Staff Report to the Agricultural Policy Advisory Commission

Application Number: 05-0620

Project Description: Proposal to construct a two-story single-family dwelling.

COUNTY OF SANTA CRUZ DISCRETIONARY APPLICATION COMMENTS

CONTION OF FIRE NOTES GRADING

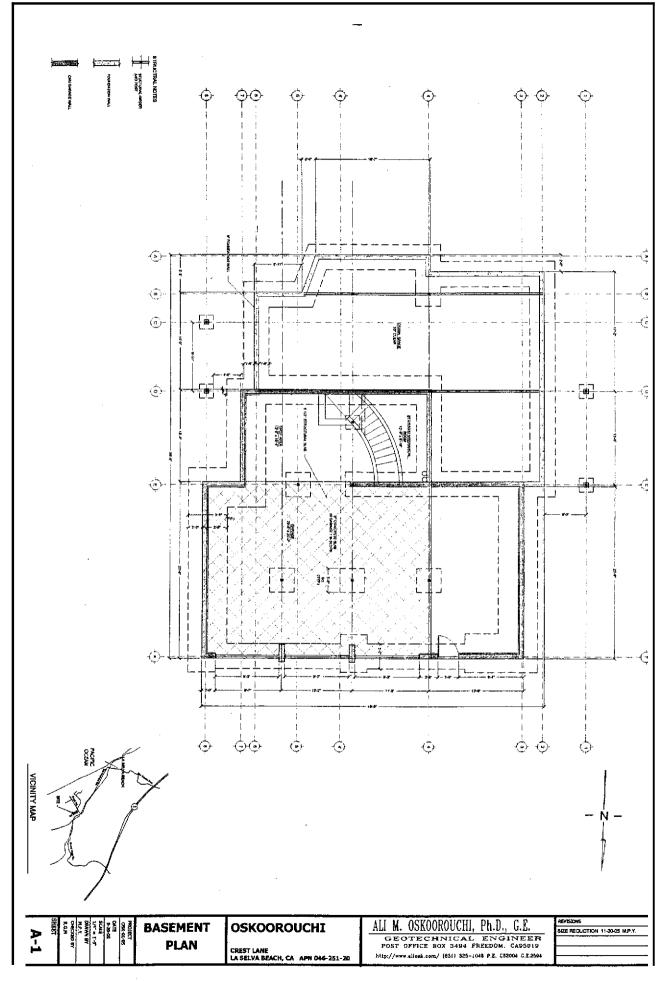
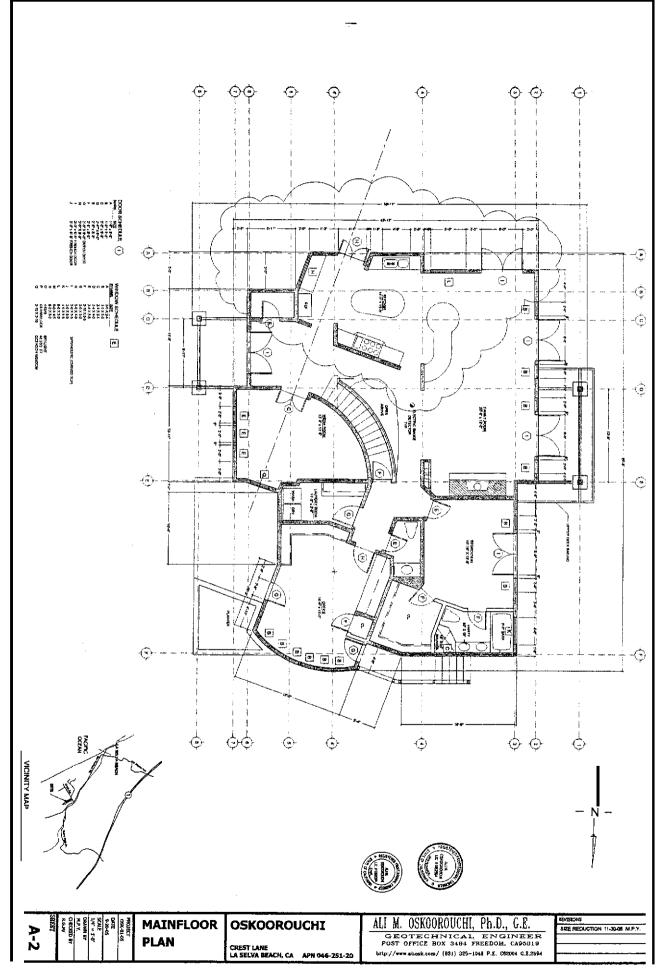
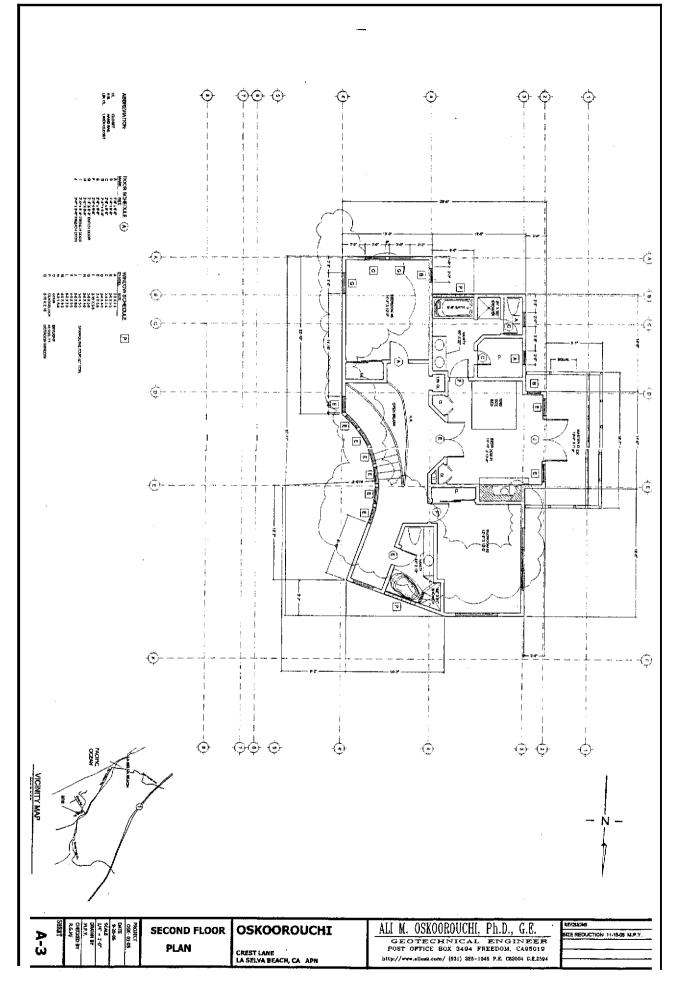
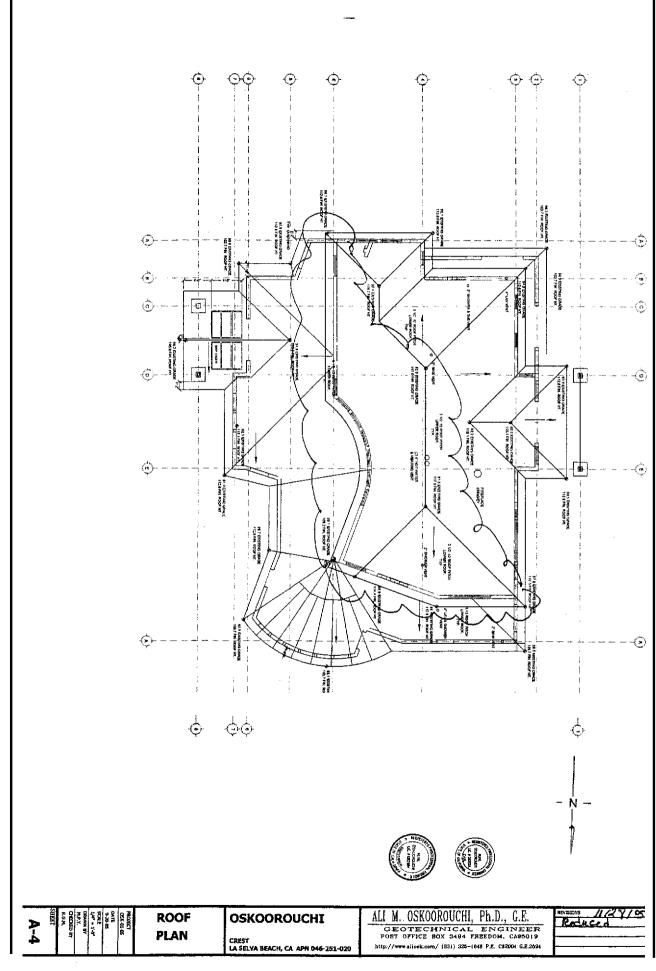
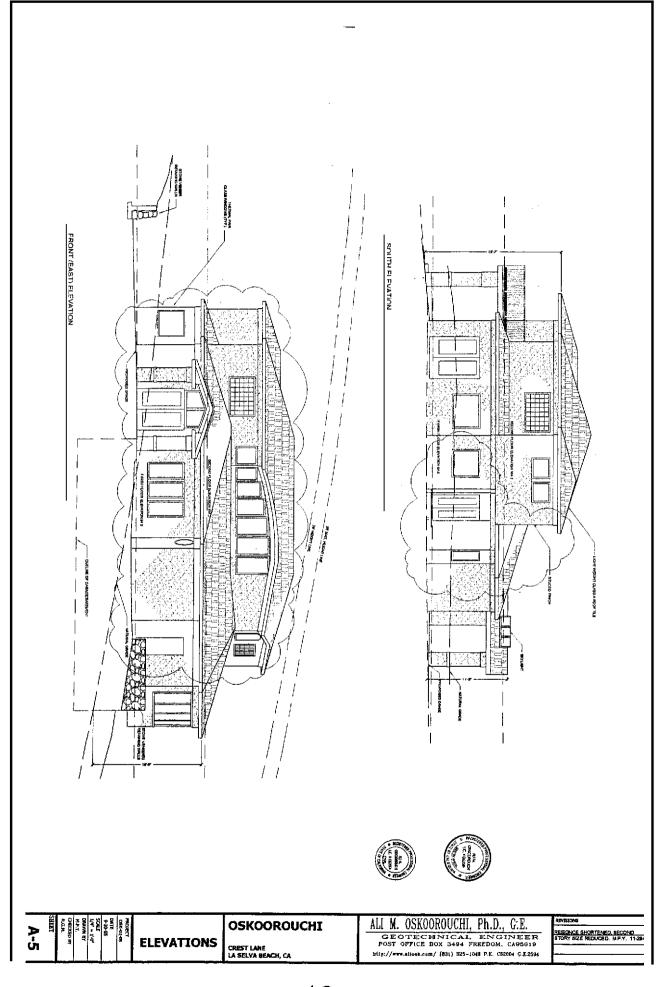
- 1. Please provide the four grading cross-sections identified on Sheet G-1.
- 2. Please separate out the grading quantities: Indicate the quantities for the basement (which is exempt from grading ordinance), the remainder of the grading for the residence, site work, and overexcavation / recompaction,

- 3. Clearly identify where the erosion control practices (silt fencing and straw rolls) are to be installed throughout the site. What will be used along the entire length of the north property line?

- 4. The north property line area contains numerous trees. If these trees are on this property please identify. The plan (Sheet G-1) currently states that the area is covered in brush. NOTE: Some trees may be allowed to be removed but that those removed will need to be replaced with new trees (coast live oaks, monterey cypress).

- 5. There appears to be an additional coast live oak tree on the property that is not shown, please identify.

----- UPDATED ON OCTOBER 12, 2005 BY KENT M EDLER ---- 1. Show the septic system on the grading plans. Please note that Env. Health generally does not allowing grading in the area of septic systems, so the grading in this area will most likely need to be eliminated.

- 2. Fill slopes are shown on the plans as steeper than 2:1 in some locations. This is not acceptable per County Code. Revise plans accordingly.
- 3. Grading should be revised so as not to conflict with the trees to remain per Bob Loveland's comments
- 4. The soils report has been accepted.
- 5. The dispersion trench northwest of the residence is located above a fill slope and should be relocated away from the fill slope.
- 6. Show finished pad elevations on sheet G-1. ----- UPDATED ON JANUARY 6, 2006 BY KENT M EDLER ----

The drainage dispersion trench is located in the keyway for the fill slope which has the potential to create instability of the fill slope. Relocate the dispersion trench to an area away from fill locations.

- B) Detention will be required only to the extent that predevelopment runoff rates cannot be maintained through other applied measures, and where drainage problems are not resolved.
- C) Detail A. sheet G-1 is mislabeled
- D) What is the condition of runoff received from upstream land areas and developments? Please clarify.
- E) County design criteria requires topography be shown a minimum of 50 feet beyond the project work limits. Please provide this extent.
- F) Applicant should provide drainage information to a level addressed in the "Drainage Guidelines for Single Family Residences" provided by the Planning Depart.. ment. This may be obtained online: http://sccounty01.co.santa-cruz.ca.us/planning/brochures/drain.htm
